DELAWARE DEPARTMENT OF TRANSPORTATION	ADDENDUMS / REVISIONS	NOT TO SCALE	SR1 / I-95 INTERCHANGE	CONTRACT 28-090-03	BRIDGE NO.	TYPICAL SECTIONS	SHEET NO. 10
	ADDENDUM NO. 3 CHANGED ITEM NO., 02/18/2011, RLS			COUNTY NEW CASTLE	DESIGNED BY:		TOTAL SHTS. 803
					CHECKED BY:

DELAWARE DEPARTMENT OF TRANSPORTATION	ADDENDUMS / REVISIONS ADDENDUM NO. 3 CHANGED ITEM NO., ADDED O.H. SIGN REMOVAL, 02/18/2011 RLS	SCALE 0 50 100 150 FEET	SR1 / I-95 INTERCHANGE	CONTRACT 28-090-03 COUNTY NEW CASTLE	BRIDGE NO. DESIGNED BY: CHECKED BY:	CONSTRUCTION PLAN

DELAWARE DEPARTMENT OF TRANSPORTATION	ADDENDUMS / REVISIONS: ADDENDUM NO. 3 VOIDED SHEET; MODIFIED ITMS DESIGN SEE SHEET 711A, 02/18/2011, JCR	SCALE 0 50 100 150 FEET	SR1 / I-95 INTERCHANGE	CONTRACT 28-090-03; COUNTY NEW CASTLE; BRIDGE NO.; DESIGNED BY:; CHECKED BY:	SIGNING, STRIPING & CONDUIT PLAN; SSC-1; SHEET NO. 711; TOTAL SHTS. 803

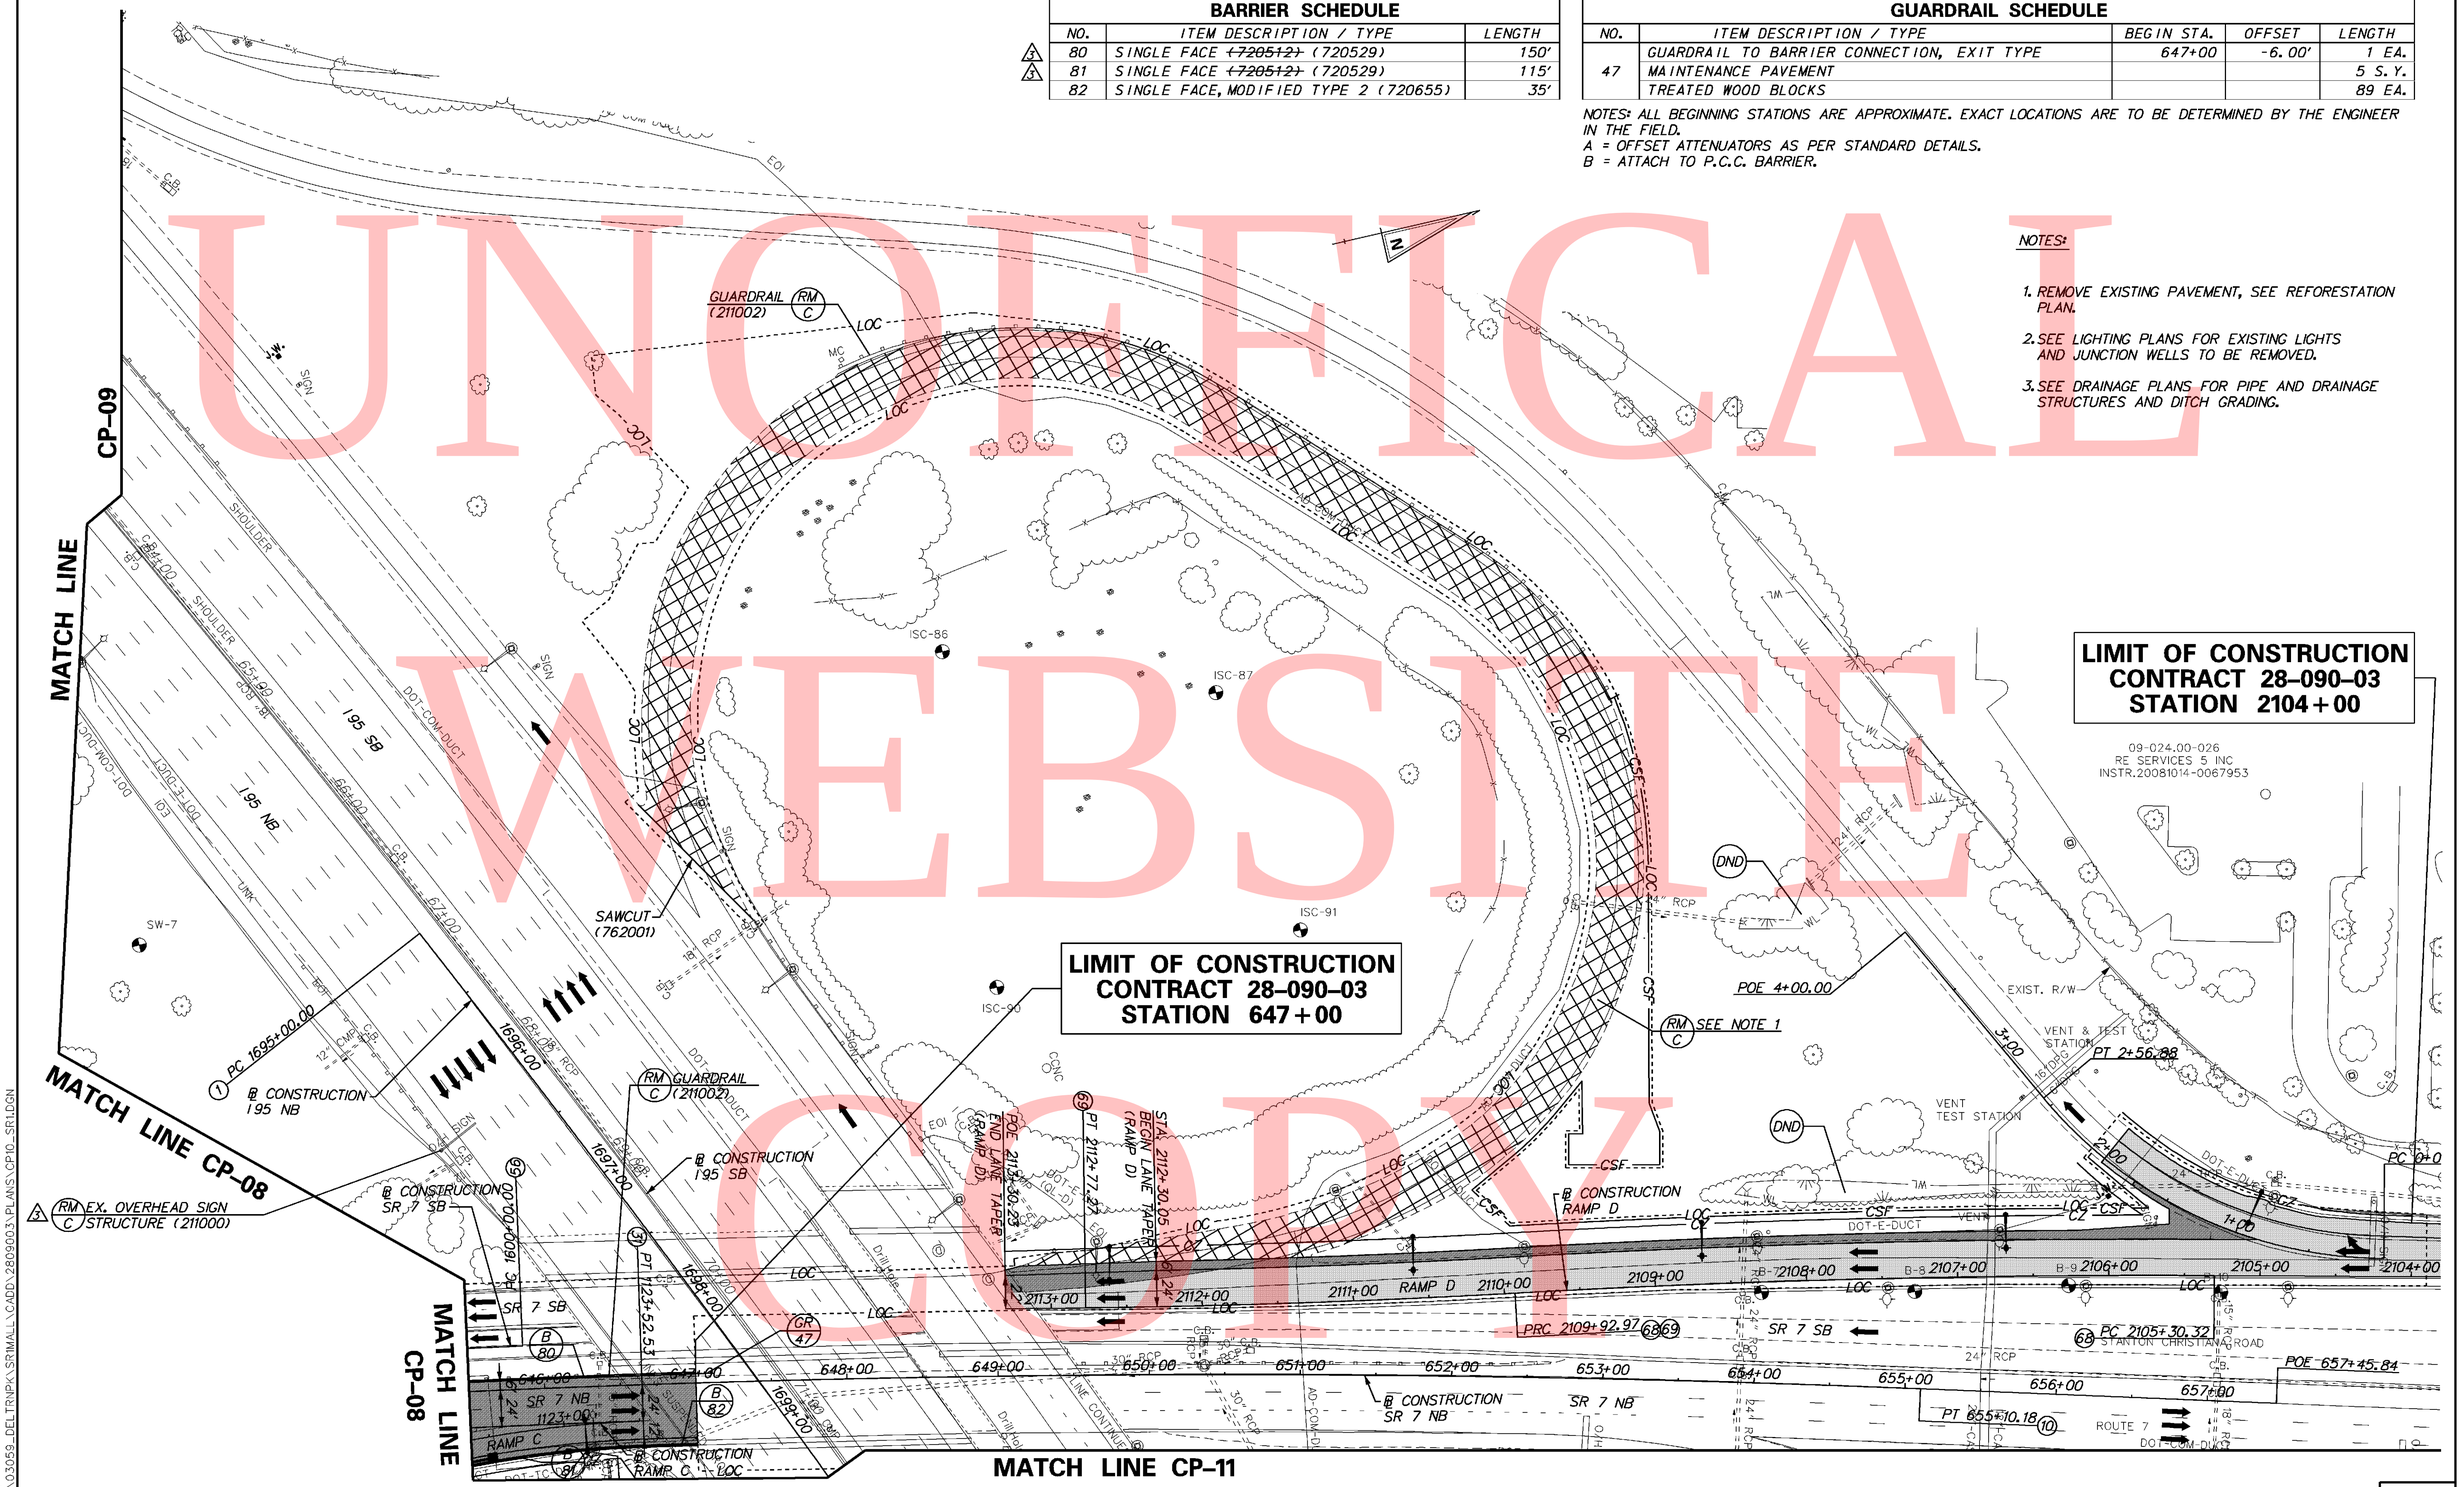
BARRIER SCHEDULE		
NO.	ITEM DESCRIPTION / TYPE	LENGTH
83	DOUBLE FACE, BIFURCATED TYPE 1(720651)	418'
84	SINGLE FACE, MODIFIED TYPE 2 (720655)	742'
85	SINGLE FACE ~~(720512)~~ (720529)	218'
86	SINGLE FACE, MODIFIED TYPE 2 (720655)	531'
87	SINGLE FACE ~~(720512)~~ (720529)	215'
88	SINGLE FACE ~~(720512)~~ (720529)	126'
89	SINGLE FACE ~~(720512)~~ (720529)	1,095'
90	SINGLE FACE ~~(720512)~~ (720529)	309'
91	SINGLE FACE, MODIFIED TYPE 2 (720655)	50'
92	SINGLE FACE ~~(720512)~~ (720529)	337'
93	SINGLE FACE, MODIFIED TYPE 2 (720655)	410'
94	SINGLE FACE ~~(720512)~~ (720529)	485'
95	SINGLE FACE ~~(720512)~~ (720529)	1,180'
96	SINGLE FACE ~~(720512)~~ (720529)	427'
97	DOUBLE FACE, BIFURCATED TYPE 1(720651)	29'
98	SINGLE FACE ~~(720512)~~ (720529)	216'
99	SINGLE FACE, MODIFIED TYPE 2 (720655)	204'
100	SINGLE FACE ~~(720512)~~ (720529)	288'

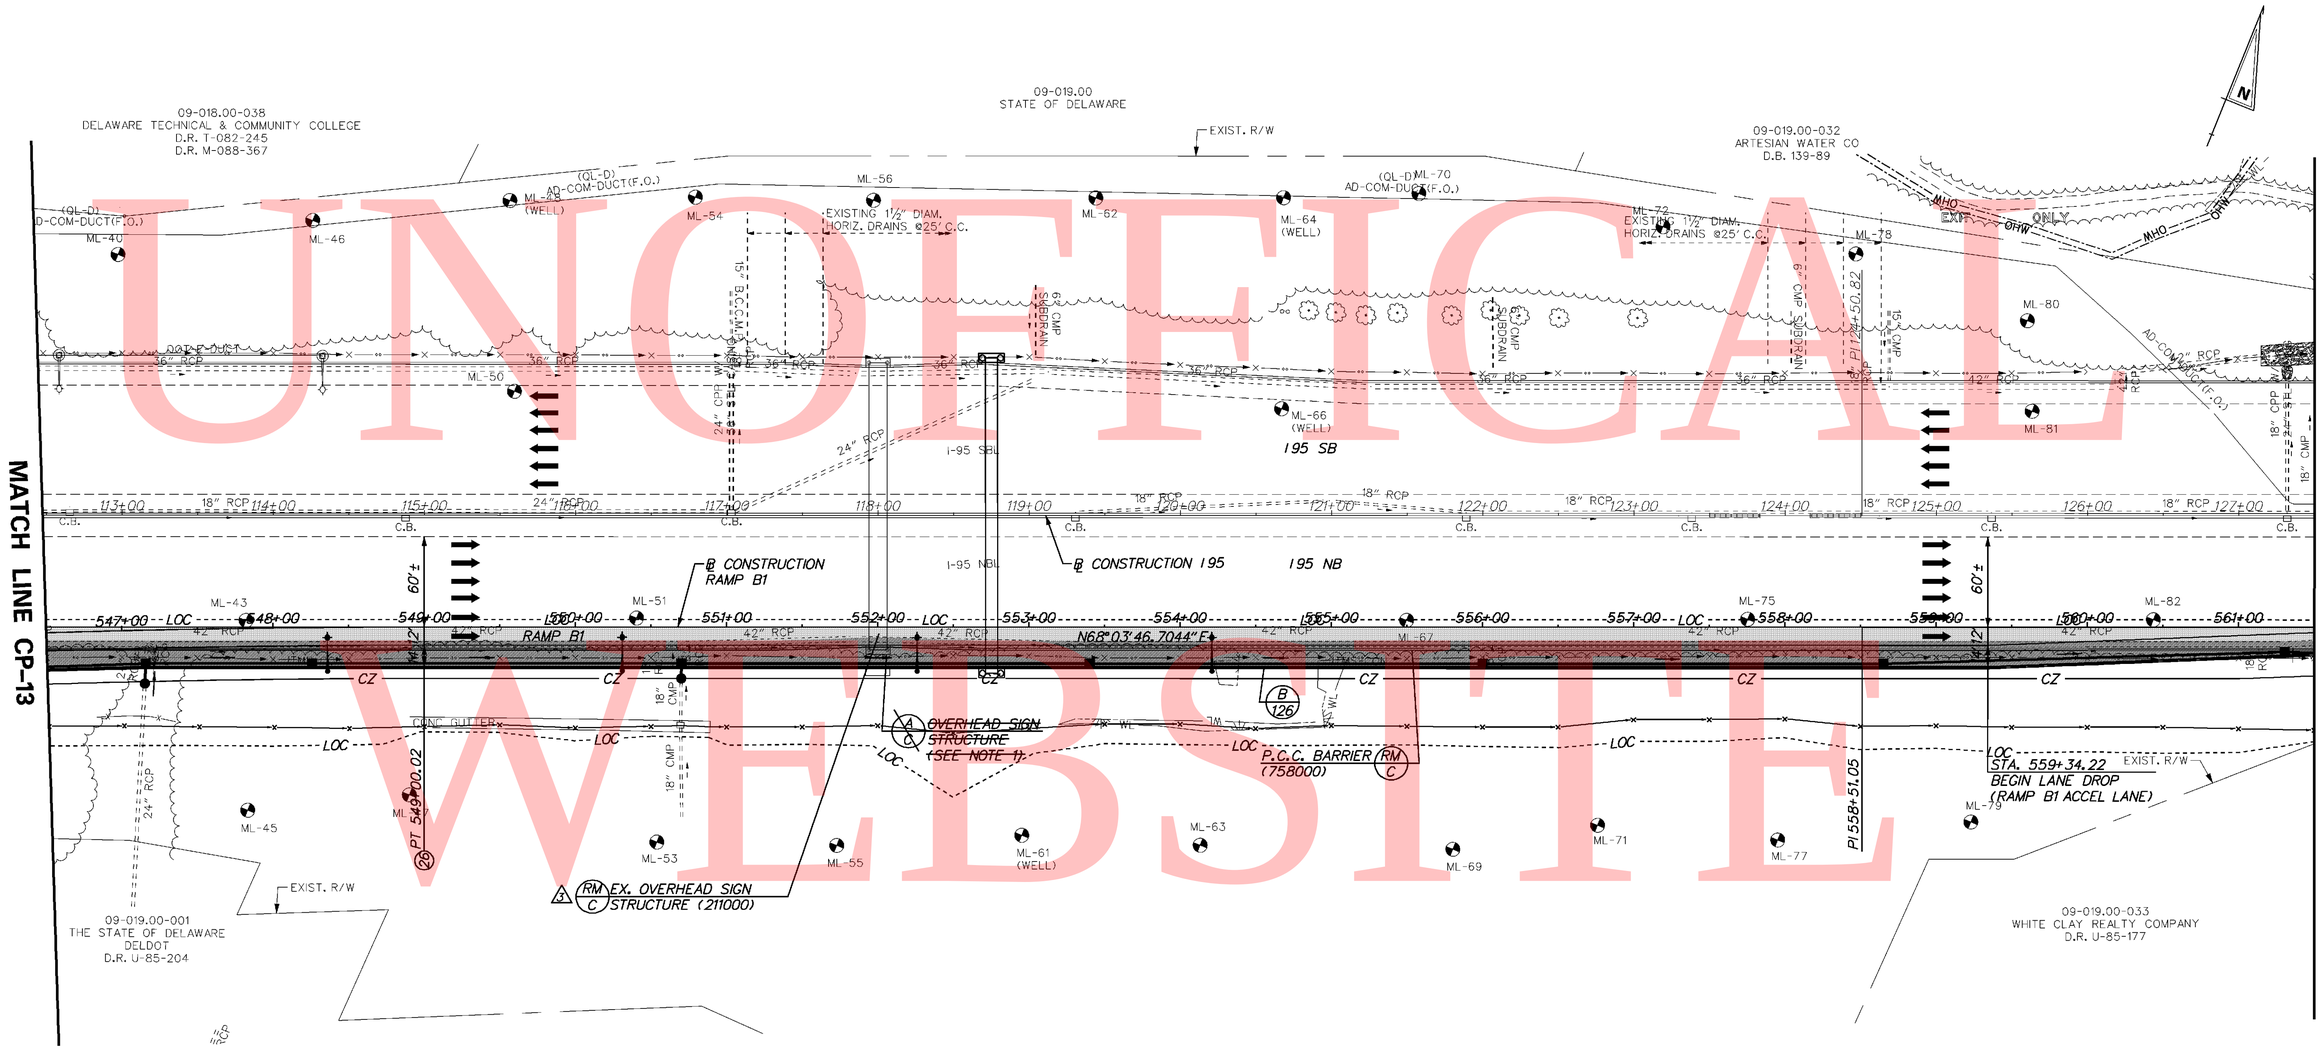
3 ~~1. MODIFY EXISTING OVERHEAD SIGN STRUCTURE. SEE DETAIL SHEET XX.~~
